City of Santa Barbara  
Planning Division

## Memorandum

**SUBJECT:** 565 Yankee Farm Road

**PRELIMINARY DRAINAGE REPORT**  
**For the Proposed**  
**HONUAKAI RESIDENCE**  
**565 YANKEE FARM ROAD**  
**APN 047-030-005**  
Santa Barbara, California

**Figure D: Proposed Drainage Areas**

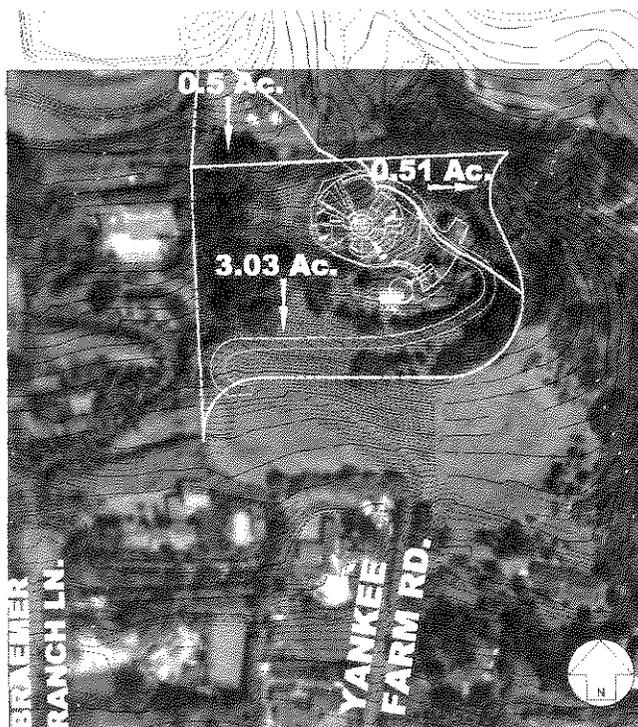
- *Provide an updated drainage plan and calculations.*

The applicant has provided a drainage plan that eliminates piping hardscape drainage off-site, which is consistent with the Storm Water Management Program. A detention basin has been added that would capture the net increase of impermeable surface runoff. There is sufficient area on the lot between the proposed residence and the property line, located downhill to the south, to allow sheet flow across the surface without impacting the neighboring properties. A drainage report is included with this memorandum.

Approximately 0.51 Ac. of the site will now drain into the unnamed drainage course and approximately 3.03 Ac. Will drain southerly (see Figure D: Proposed Drainage Areas.)

**Exhibit 3: Revised Lower Level Floor Plan**  
(Achieves basement credit without changes to grading plans.)

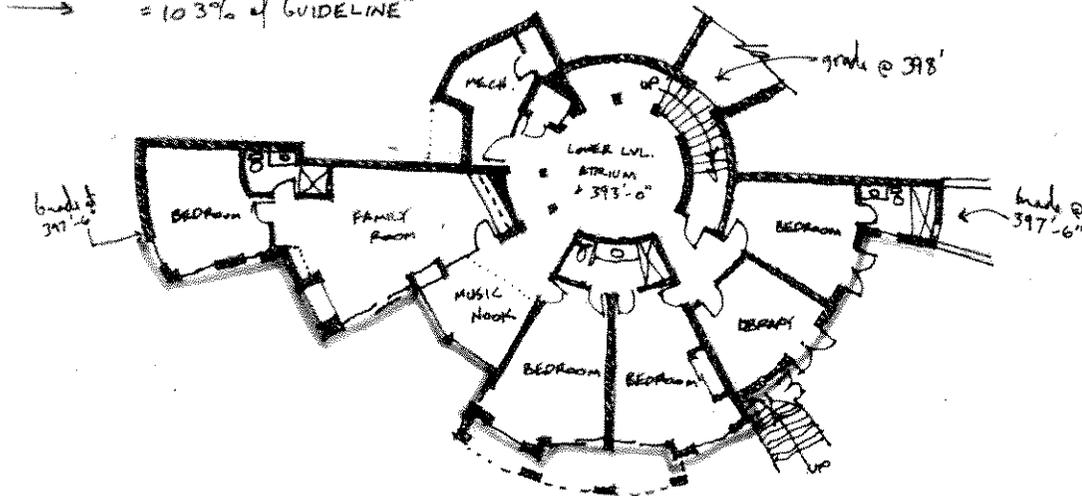
- *Consider reducing the size of the structure and returning to design review for input.*

The applicant has demonstrated that additional fill against the building could reduce the amount of "exposed" walls on the lower floor, thus qualifying for a basement credit. With the basement credit (for both the lower floor and the cabana), the project would be 103% of the recommended FAR. Thus, there have been no significant changes to the structure that would require further conceptual review by the ABR. On the lower floor, one wall was extended from the building, which allows for a roof element to be added from the upper floor. Additionally, the applicant has provided diagrams, which are attached to this memo, to demonstrate that portions of the upper and lower floor walls are offset. By offsetting the walls, the building would not read as one solid two story mass. The applicant will bring a physical model to the Planning Commission meeting to help with visualizing the project.

We also studied the basement credit rule and found it very easy to meet. We were able to achieve the basement credit by slightly reducing the amount of linear length of exposed walls and increase the amount of buried walls. There was no effect to the grading plan or the need for any additional retaining walls to manipulate grades around the perimeter of the structure. The solution ironically increased square footage by 180 sf to achieve compliance with the language of City regulations as adopted, but at the same time reduced the amount of 2 story vertically stacking walls from 8% of the project to a mere 4%. (See Exhibit 3)

REVISED FLOOR AREA: 3,310 S.F.  
(vs 3,125)
